PTRAN2024022

Re: Redtail Winery Traffic Impact Study Report – Responses to Peer Review and County Comments

Access Sightline Analysis

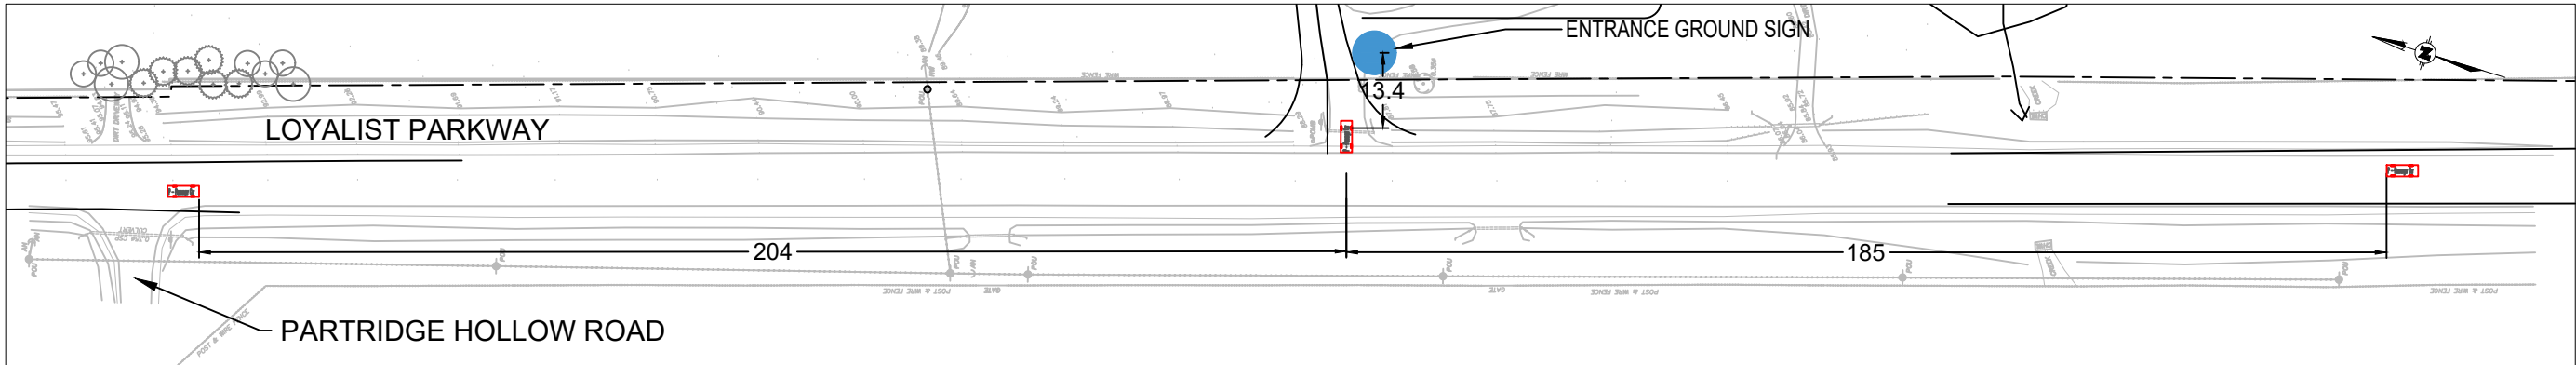
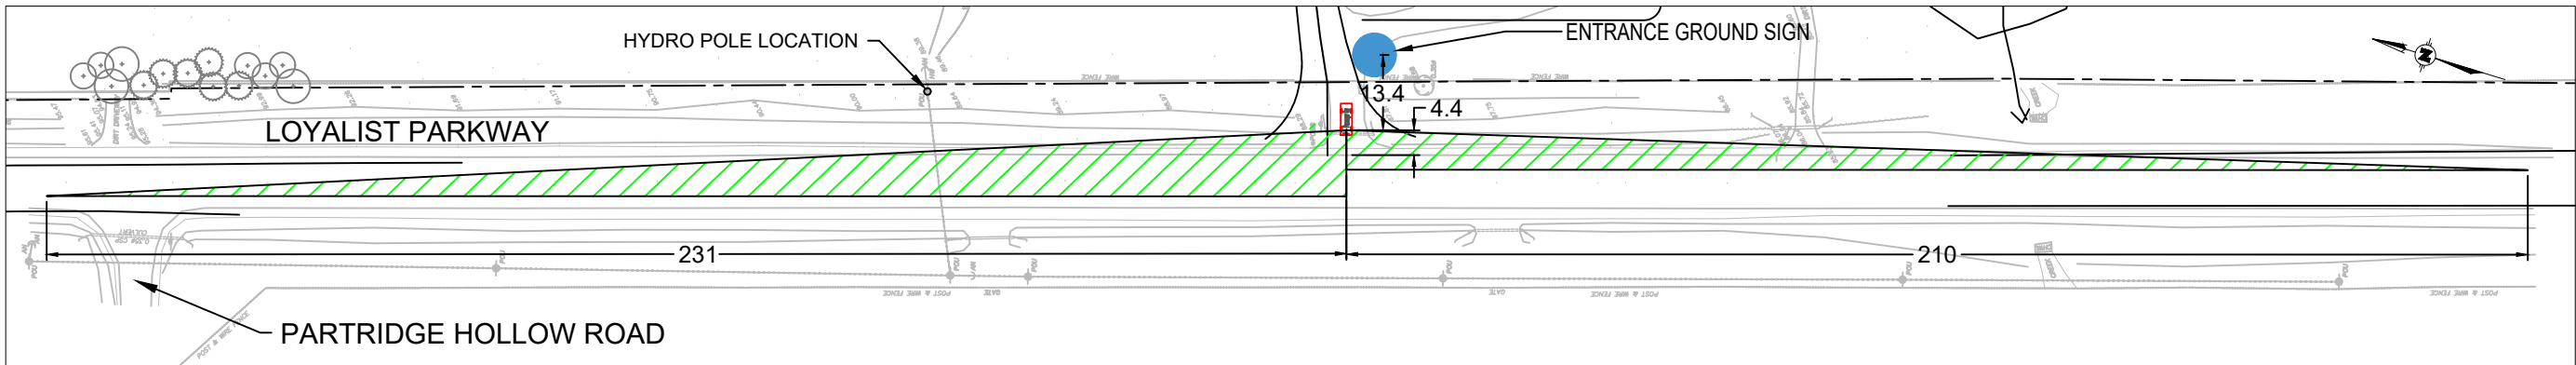
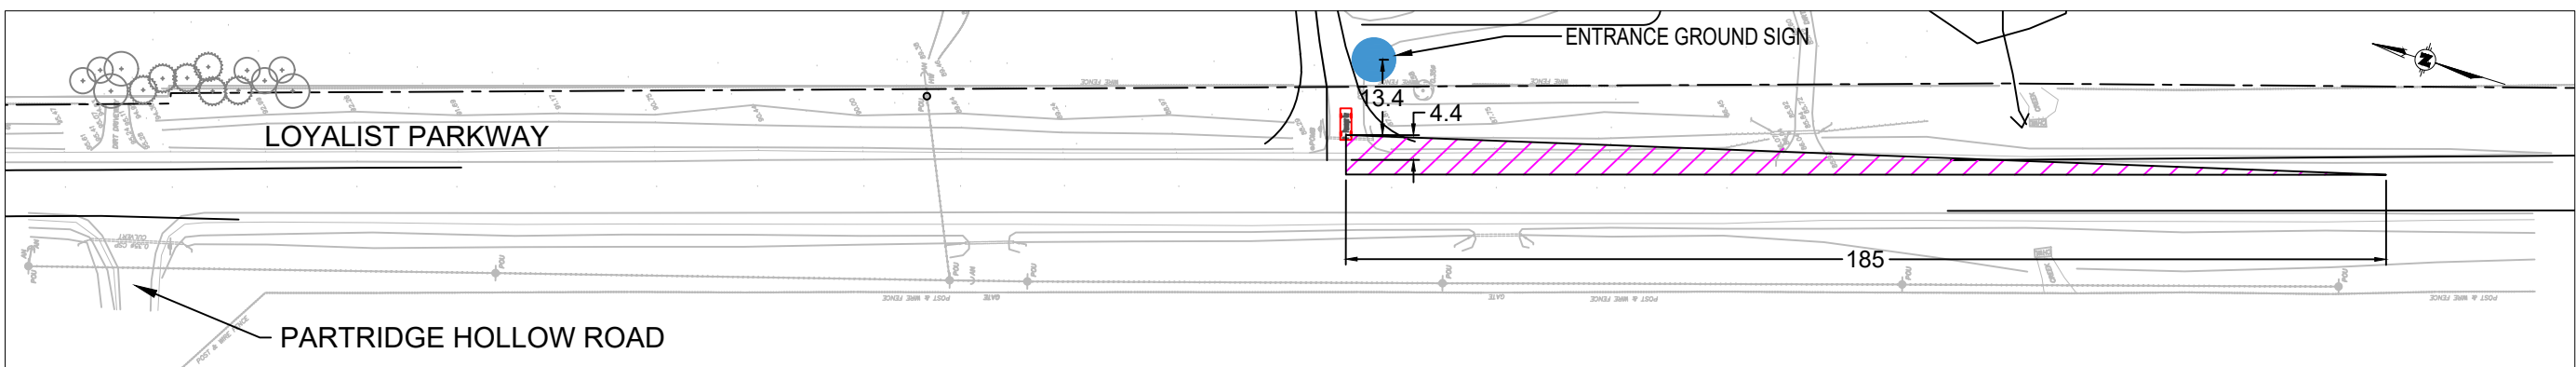
Notwithstanding, we note that the available sight distance is shown in the TIS as 210 m and not ">220 m". Based on our review using available aerial mapping and Streetview images, we agree that the sightline is somewhat longer than 220 m. We also note that there is no reference for the 1.05 adjustment factor used by the consultant. In the October 2021 Traffic Brief, Greer Galloway applied a 1.10 adjustment factor (10% increase). We find that the latter is consistent with the TAC manual for

grades less than 4%. Applying the higher factor would result in a sight distance requirement of 231 m, which is likely met in the field based on our review.

Will any roadside poles for hydro or telecommunications be located within the required clearance zone from the traffic lane following widening of Loyalist Parkway? Please verify that this is not an issue and indicate clearance zone requirement as per the applicable engineering standard.

As noted in the March 2026 Response Letter the sight distances were adjusted by 1.05 to account for the downhill grade. This was based on Table 2.5.3 – Stopping Sight Distance on Grades in the TAC Manual for a grade of 3%.

We acknowledge that an adjustment factor of 1.10 will account for a downhill grade of 4%, and using this factor will require a sight distance of 231 m as summarized in **Table 1**. The results in **Table 1** show that the proposed site access has adequate sight distances for a design speed of 100 km/h when accounting for a downhill grade of 4%. The access sightline analysis is provided in **Attachment 1**.

No roadside poles for hydro or telecommunications will be located within the required clearance zone as shown in **Attachment 1**.
